MEMORANDUM

TO: Madeleine Reinke, Kimley-Horn and Associates, Inc.
FROM: Cynthia Thye, Planner 1
DATE: December 31, 2025
SUBJECT: SP25-119: Lincoln Professional Park L2 - 7 Brews Coffee – Site Plan Review Comments 02

PROJECT NO.
 296237001
 SHEET
 296237001_SP
 3

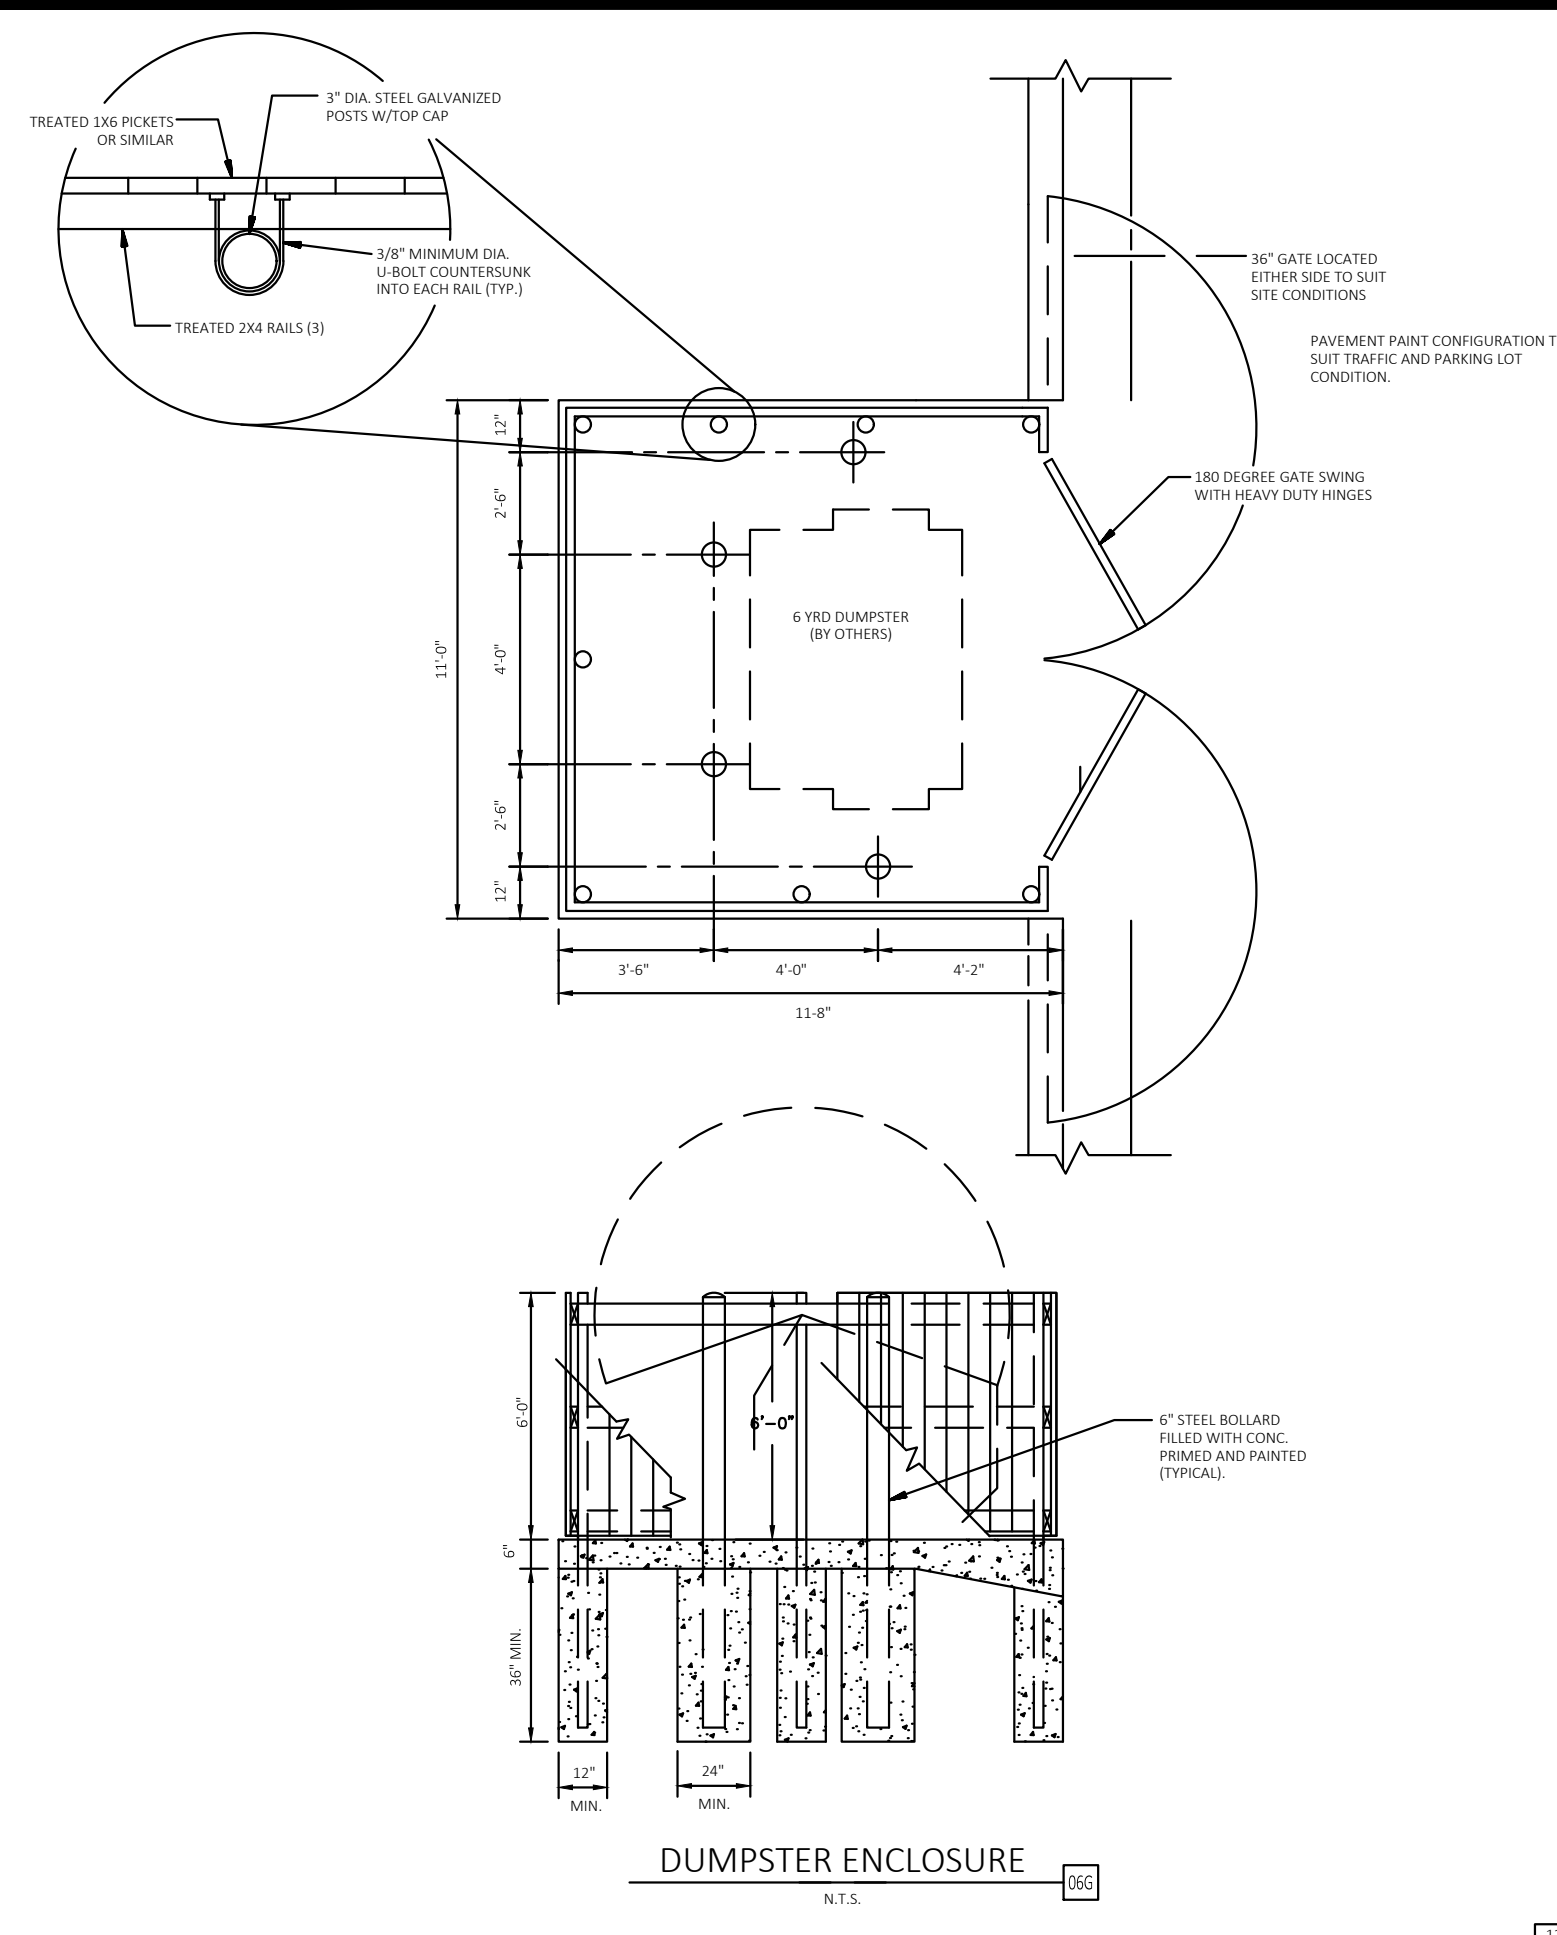
- 1. **Per LDO Administrative Manual regarding title page: add “Page 1 of __” to title and add Land Use Summary Table. Also, number pages correctly on Sheet List Table and change sidewalk sheet C3.3 reference on page 3.**

- 2. **Add legend for hardscapes surfaces indicating material to be used.**

- 3. **Per LDO Administrative Manual, indicate feet from building to property lines on all four sides. This will also be needed for FLC inspection. Also, add length from building to driveway to ensure DDS compliance.**

4. Add a second table to the plaza that is wheelchair accessible.

5. Add a trash receptacle on patio and include on cut sheet showing, dimensions, image, material and color.

6. Incorporate Site Data Table into Land Use Summary Table on Cover Sheet per LDO Administrative Manual page 25.

Add legend for hardscaped surfaces and materials.

Add trash receptacle, include in cut sheet dimensions, image, material, and color.

Revise sheet number.

Add a second table that is wheelchair accessible.

Add length from building to driveup

Incorporate this information into Land Use Summary Table on Cover Sheet per LDO Administrative Manual page 25.

Emerson Bike Rack Embedded Product Drawing

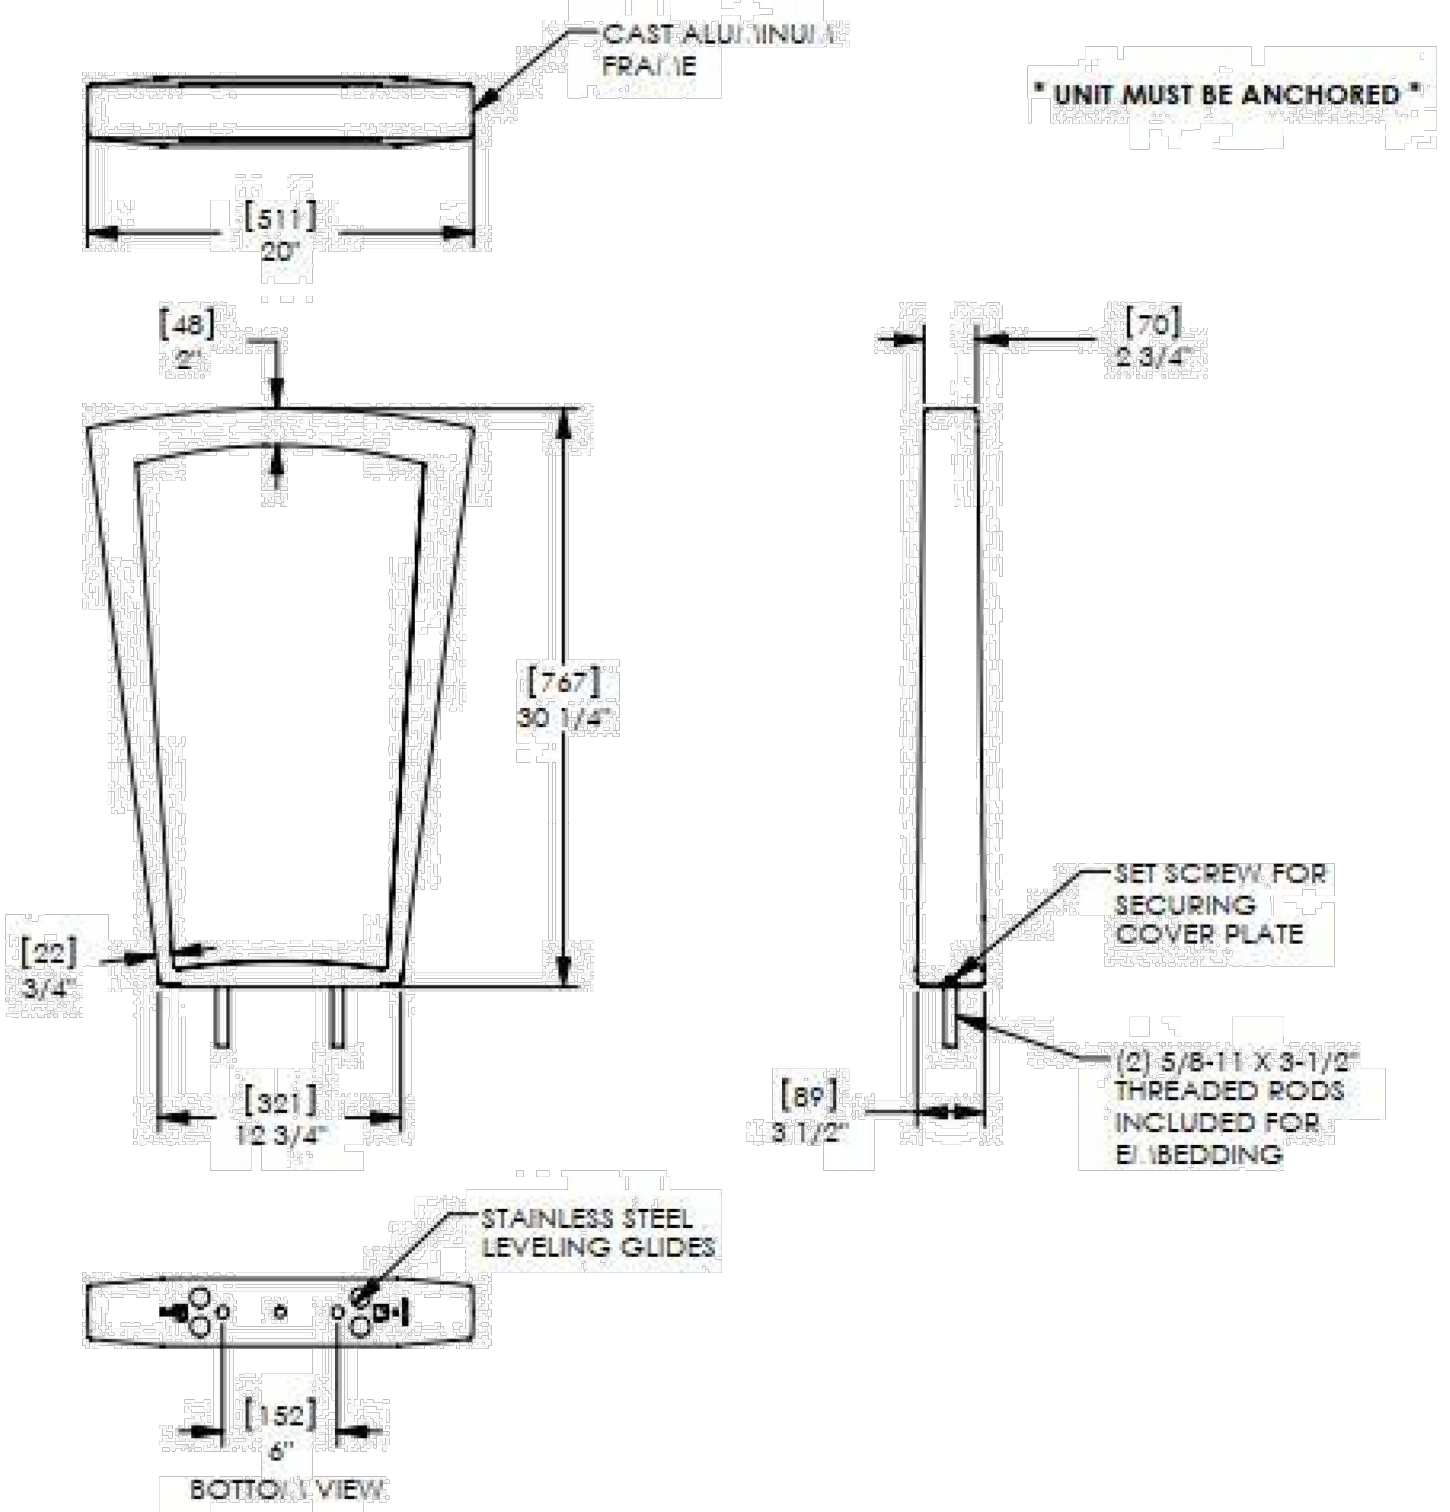
7. Bike rack sheet C3.1 is missing. Add details on bike rack including size, image, material, and color.

PROJECT NO.
 296237001
 SHEET
L2.0

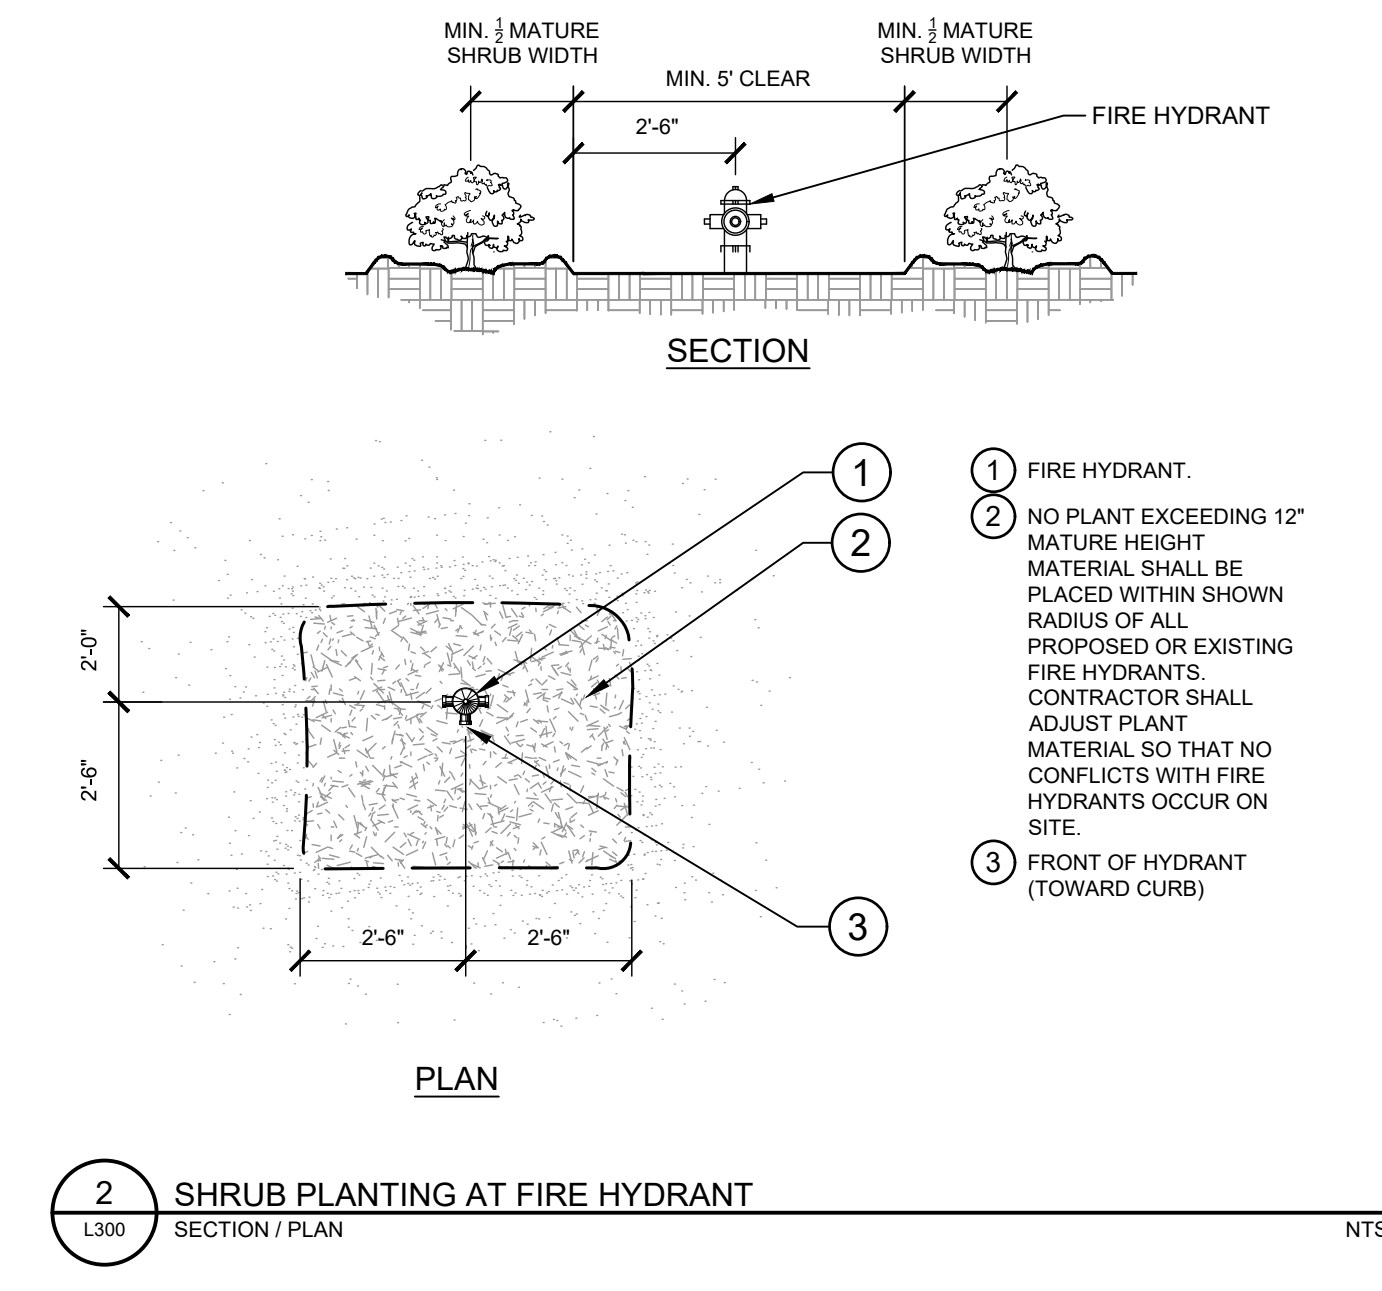
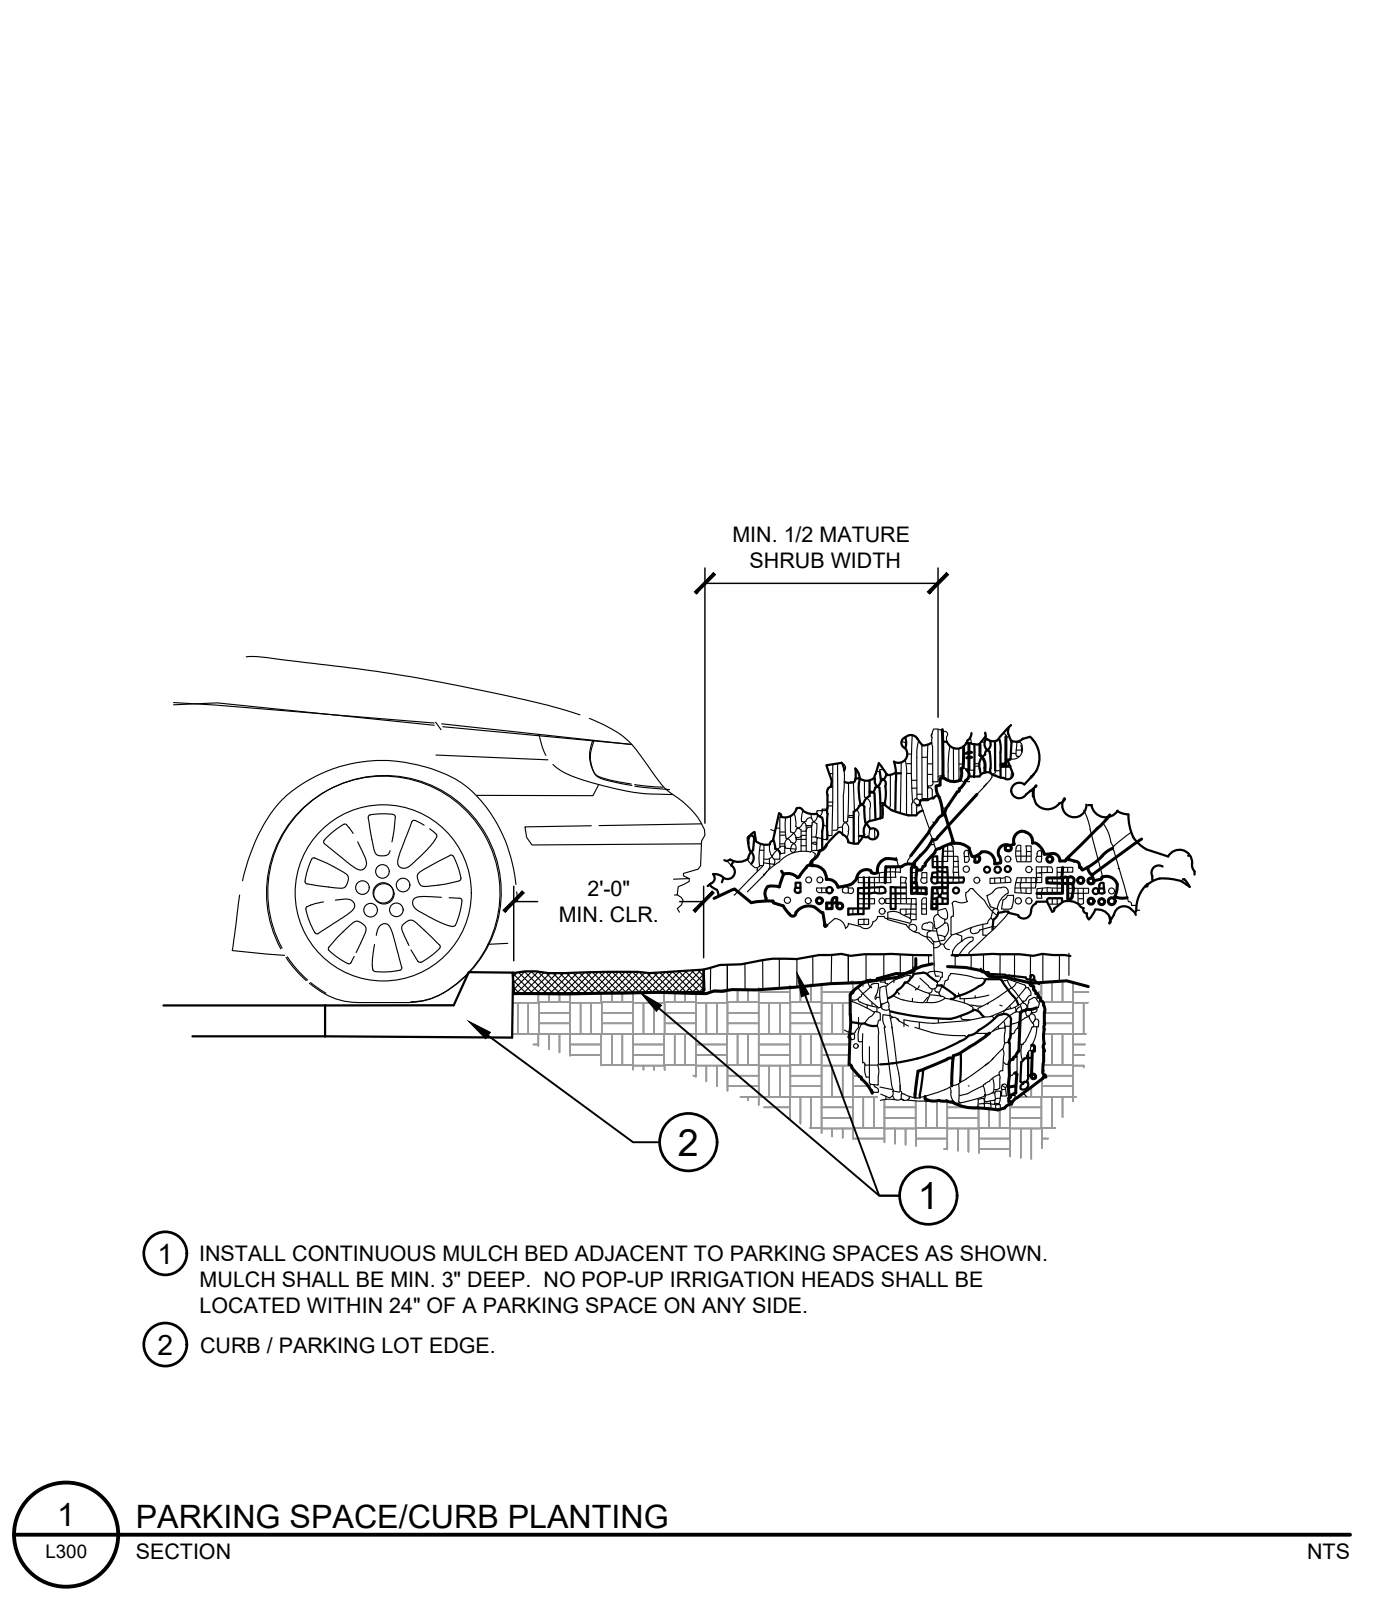
9. Regarding Landscape Requirement Table: 1) revise overall landscape reequipments calculations; 2) add "P1" to Site Perimeter subtitle; and 3) revise streetscape requirements to 1 tree per 40 linear feet. Recalculate. If parking lot and perimeter landscaping do not collectively meet minimum landscaping requirements, add site interior landscaping.

These are not correct. Recalculate.

Add: P1 (this is a min. six foot area per LDO 13.08.090(g)(4).

Revise
